August 1, 2024  
AVO 37449.004

**Re: Greystar Multifamily -Review #1**

Halff was requested by the City of Sanger to review the Final Plat and Civil drawings for the Greystar Muti-family Development. The submittal was prepared by Clay Moore Engineering and was received on July 18, 2024.

PAVING, STRIPING AND SIGNAGE  
 PLAN

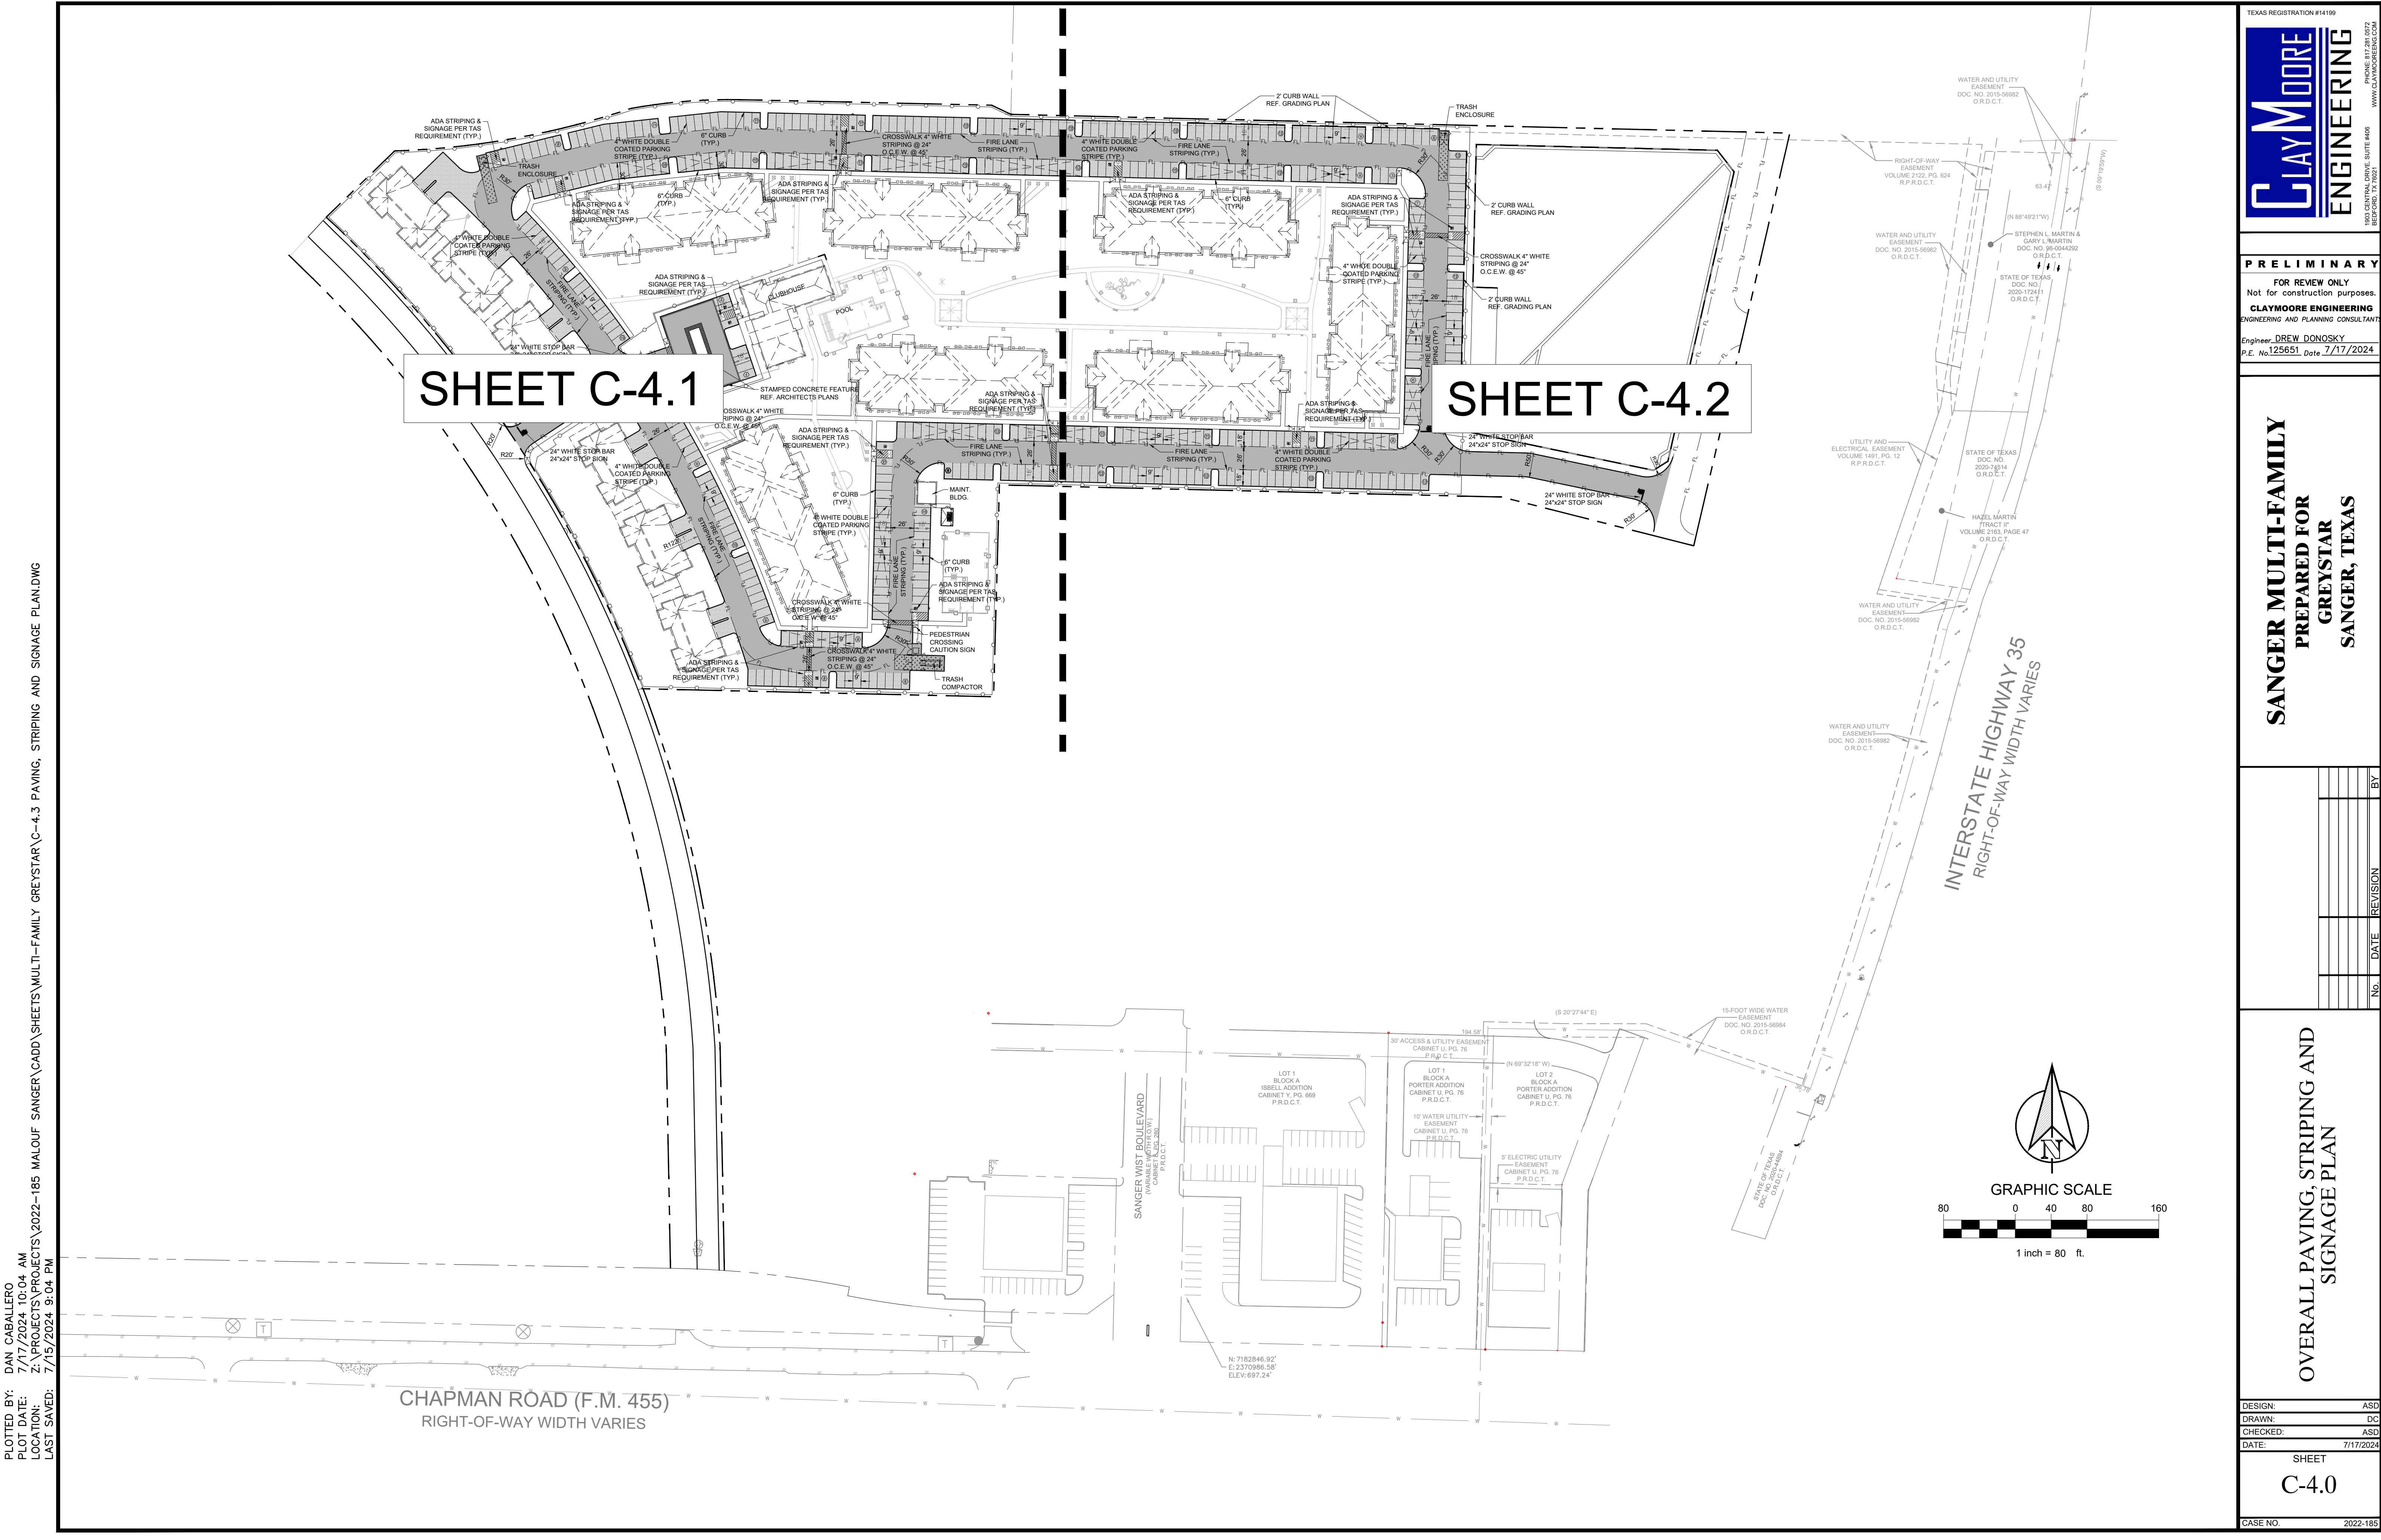
1. Provide striping information for the roadway.
2. Provide the geotechnical report.
3. The preliminary plat references PD 12-32-22. Clarify in the notes section.
4. Show how parking was calculated and provide enough information to verify that it matches the approved PD.

Show how this is calculated. Show that this matches the approved PD

what are the plans within the roadway

FENCE PLAN

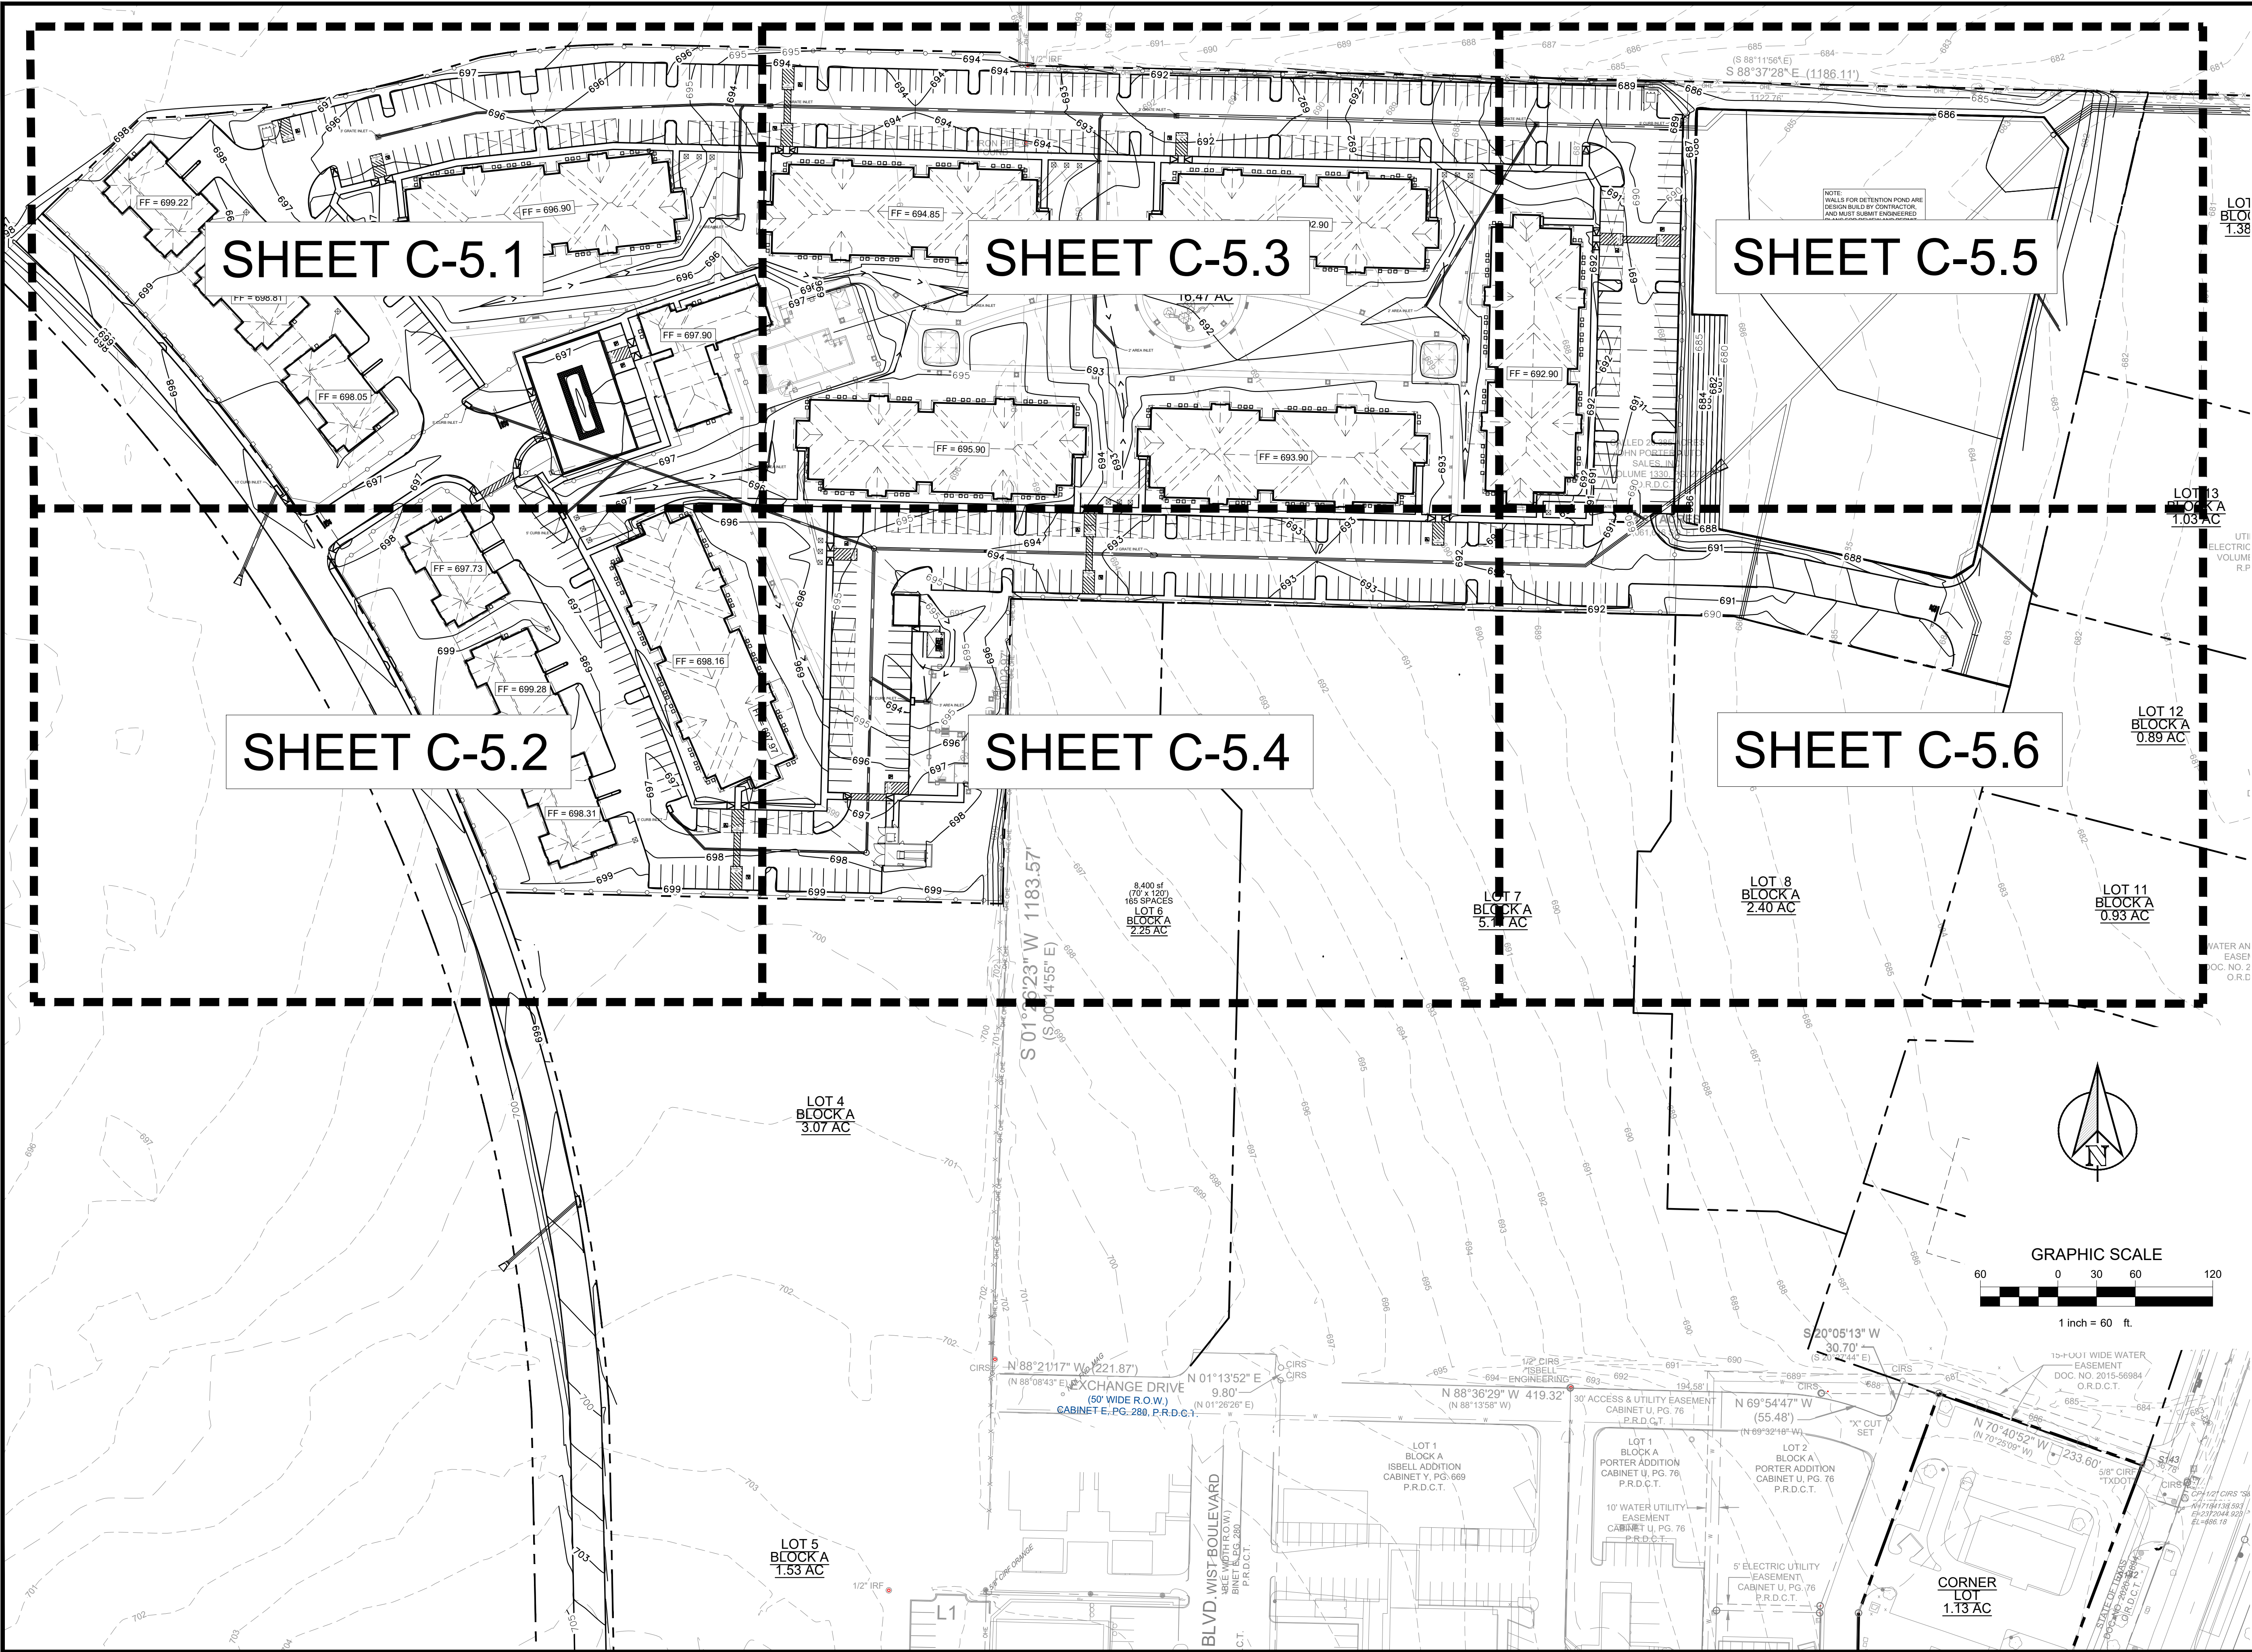
Provide gate details.  
must conform to  
ordinance 10.105(3)

DESIGN: ASD  
 DRAWN: DC  
 CHECKED: ASD  
 DATE: 7/17/2024  
 SHEET  
**C-6.0**  
 CASE NO. 2022-185

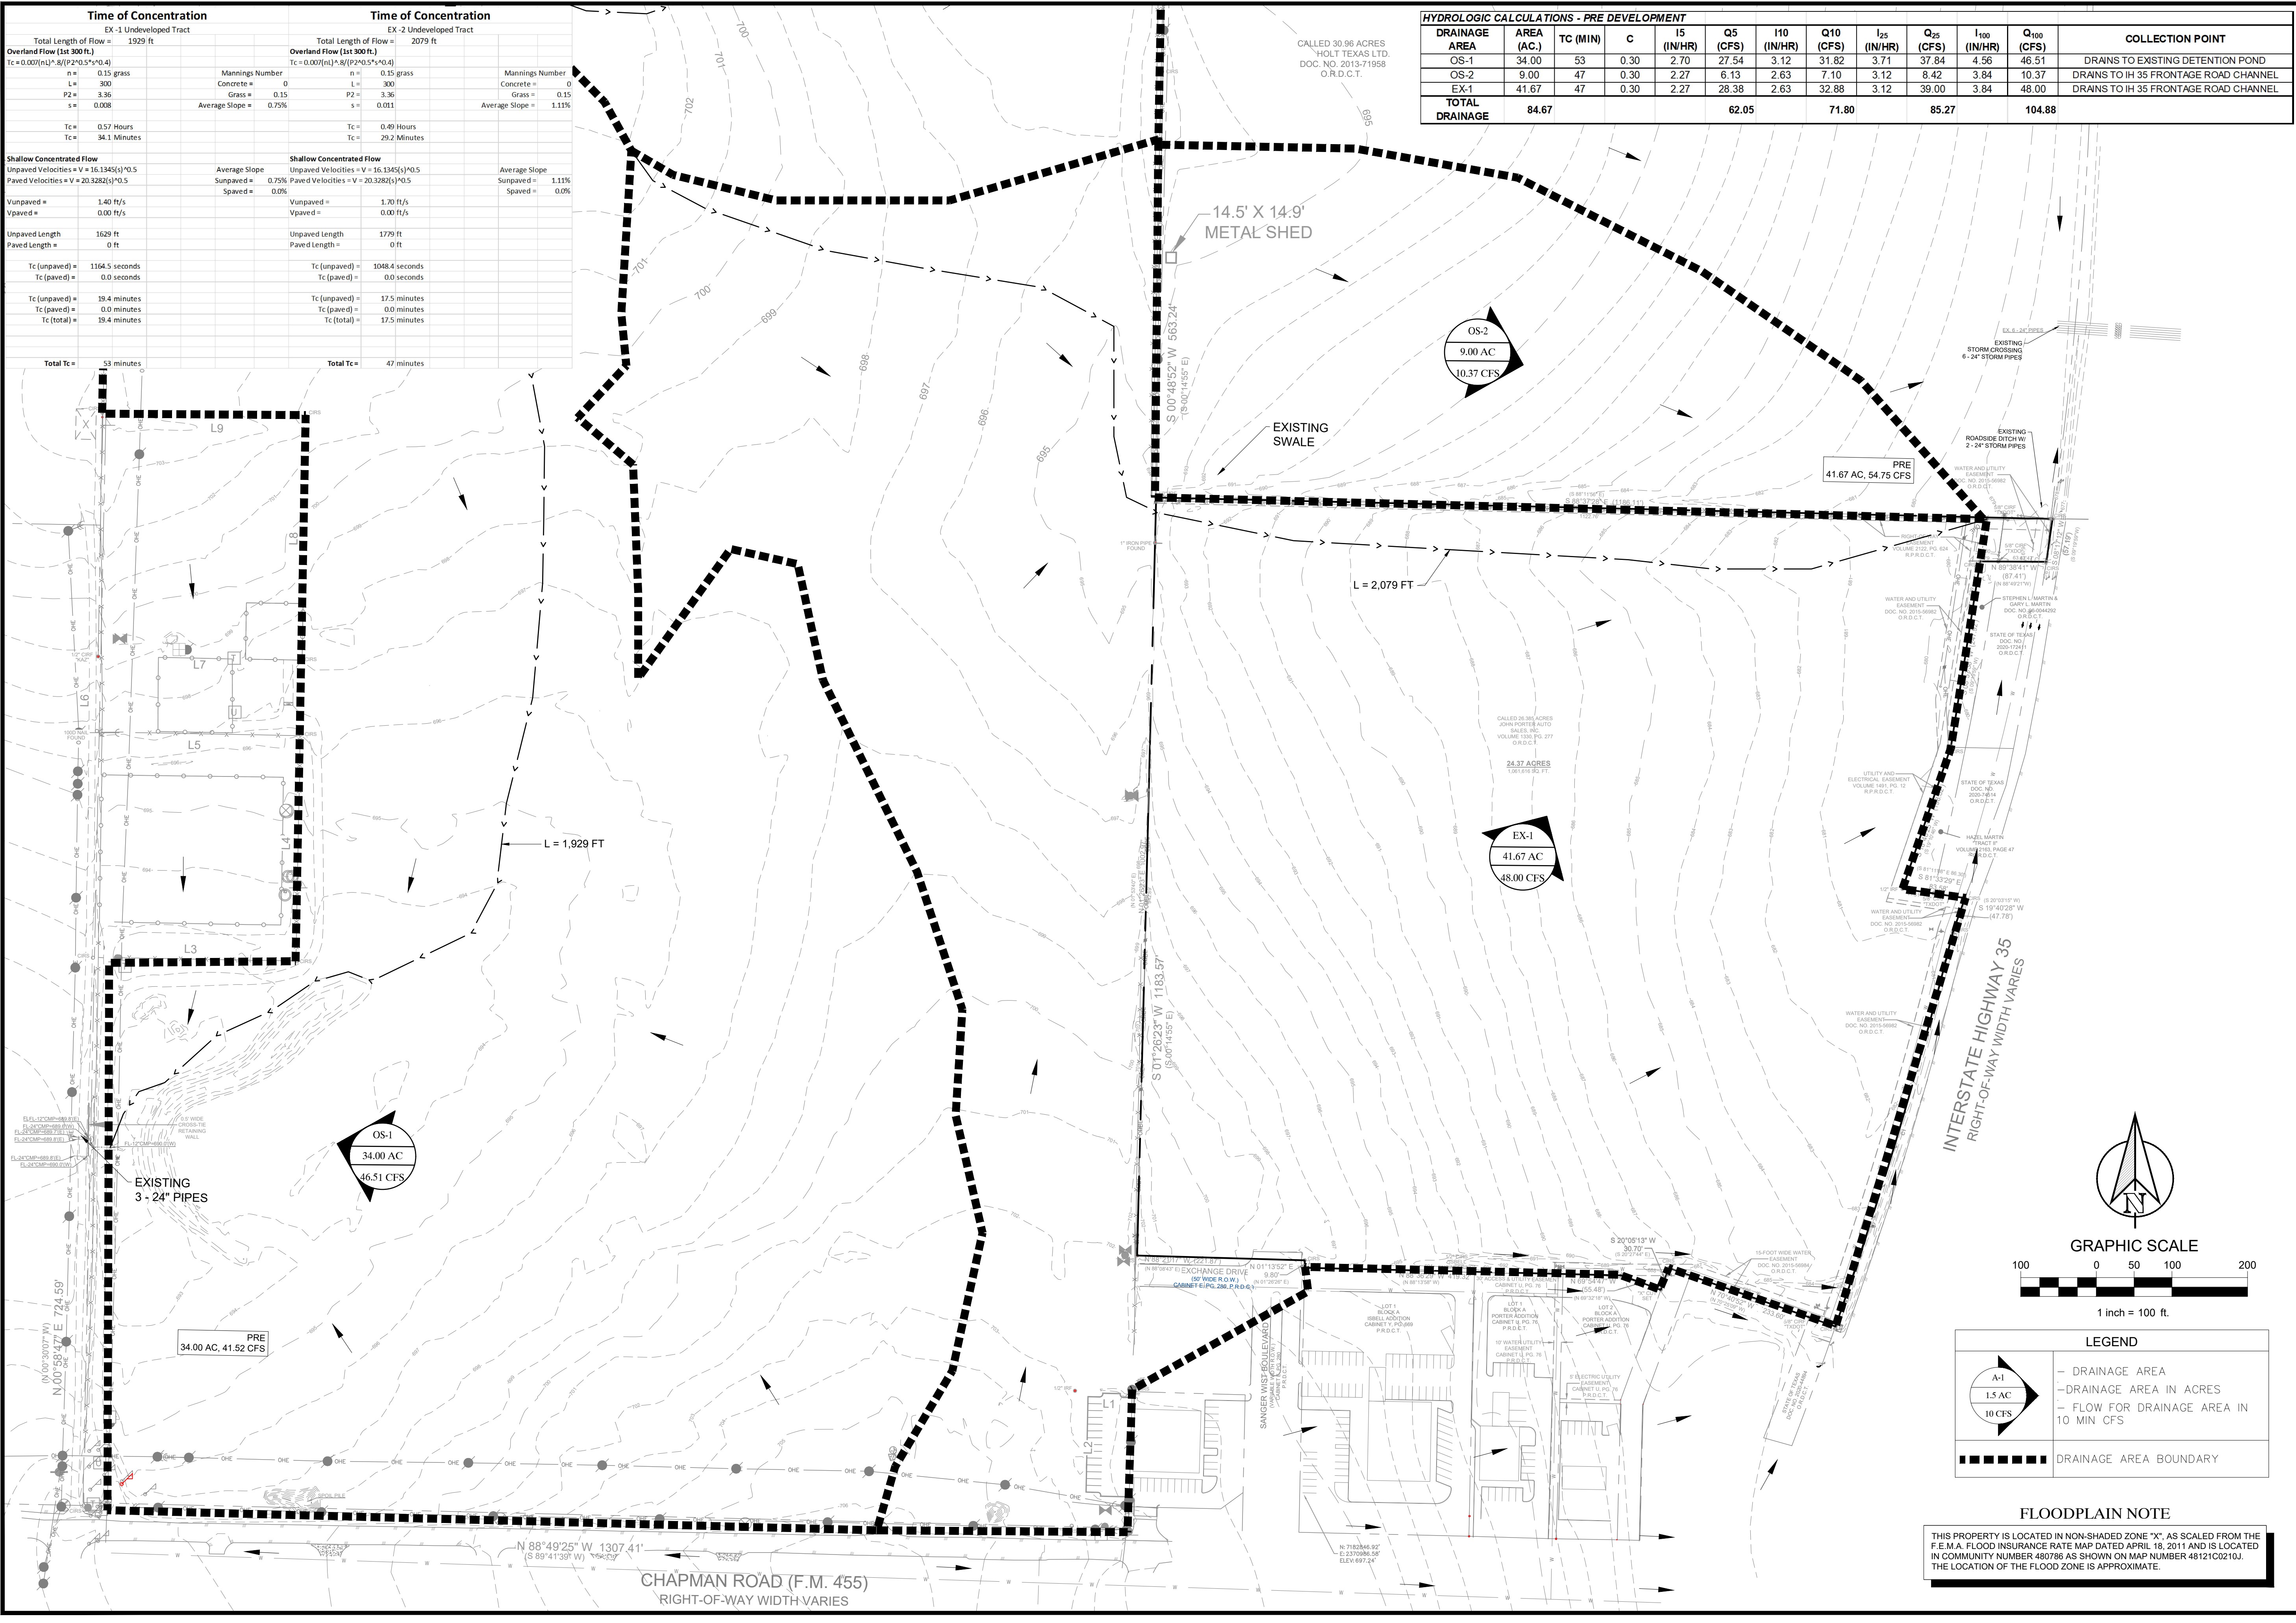
Profile and provide HGL/hydraulic data for the proposed ditch. The design must meet requirements outlined in ordinance 10.106(d)9(B)

Please provide an updated drainage study. Comments provided in April

Does not match previous sheet
